Office Action Summary

10/773,107

RHODES ET AL.

DETAILED ACTION

FIG. 4

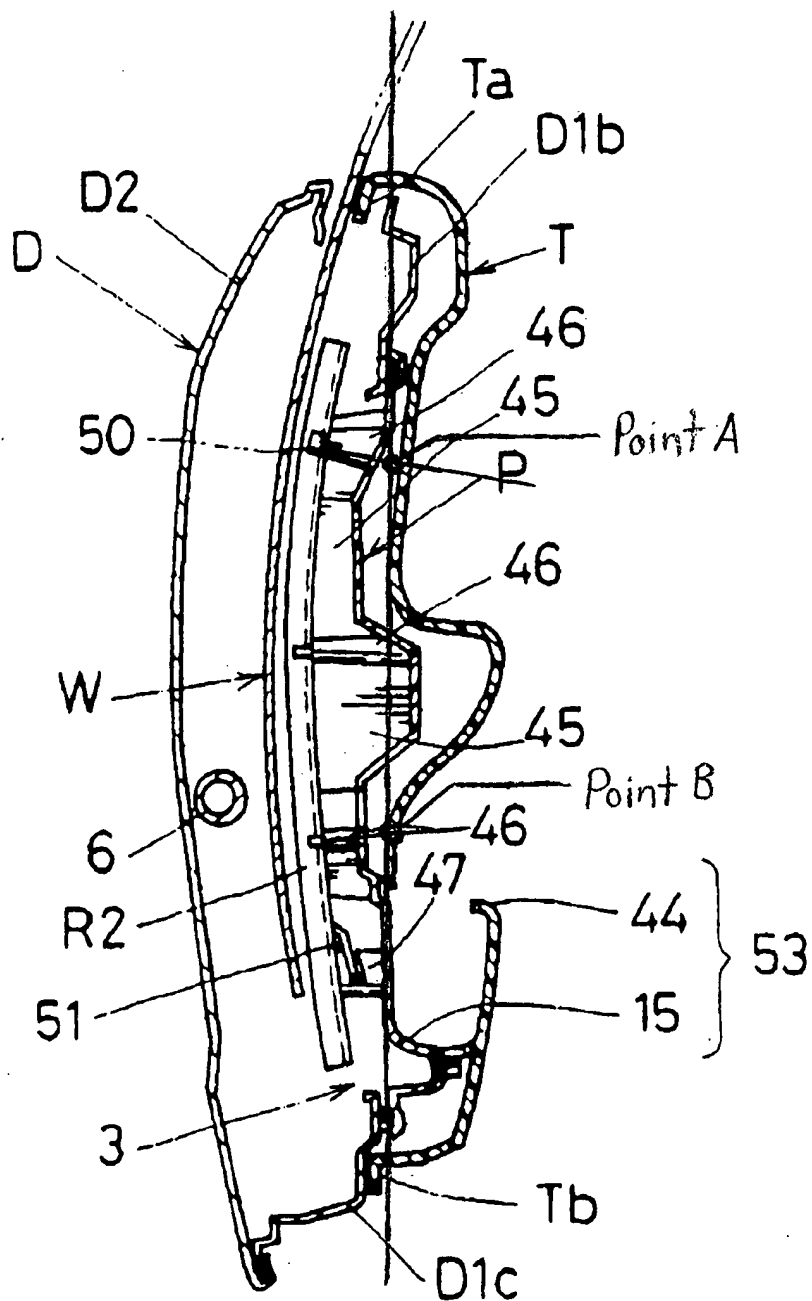
Nishikawa et al. disclose a door module with a window regulator rail (R2) and a trim panel (P). The window regulator rail (R2) can be separably fixed to the trim panel (P). The window regulator rail (R2) is fastened to a part of the door, the trim panel (P). A line projecting from the point where the window regulator rail (R2) is attached to the trim panel (P) and perpendicular to the window regulator rail intersects a plane defined by the trim panel at a point outside of the trim panel, as seen in the Attachment of this office action. In reference to claim 3, a window regulator (R1) is disclosed and the window regulator rail (R2) is a guide rail. In reference to claim 4, an electric window regulator control (40) is attached to the trim panel (P) and has wires that connect it to the window regulator (R1). In reference to claim 7, Figure 4 shows the window regulator rail attached to the trim panel (P) in an upper region of the window regulator rail (R2). In reference to claim 8, a second fastening point is located on the lower region of the window regulator rail (R2) where the rail (R2) is connected to the trim panel (P). In reference to claims 9 and 10, a lock (33) and a door handle (30) are detachably mounted to the trim panel (P). The door handle (30) actuates the lock (33).

8. The applicant has argued that the 35 USC 102(e) rejections based on Nishikawa et al. do not anticipate the claimed invention. The examiner has reviewed the rejection and realized that the plane defined in Attachment 2 of the previous office action was incorrect. This rejection has been rewritten and a new illustration has been attached that corrects this error. The window regulator rail (R2) is connected a panel (P) that meets the claimed limitations of the door trim. The panel (P) is part of the door. The fastening point defined by this connection meets the limitation of having a line extending perpendicularly from the rail to intersect the plane defined by the trim outside the door trim.
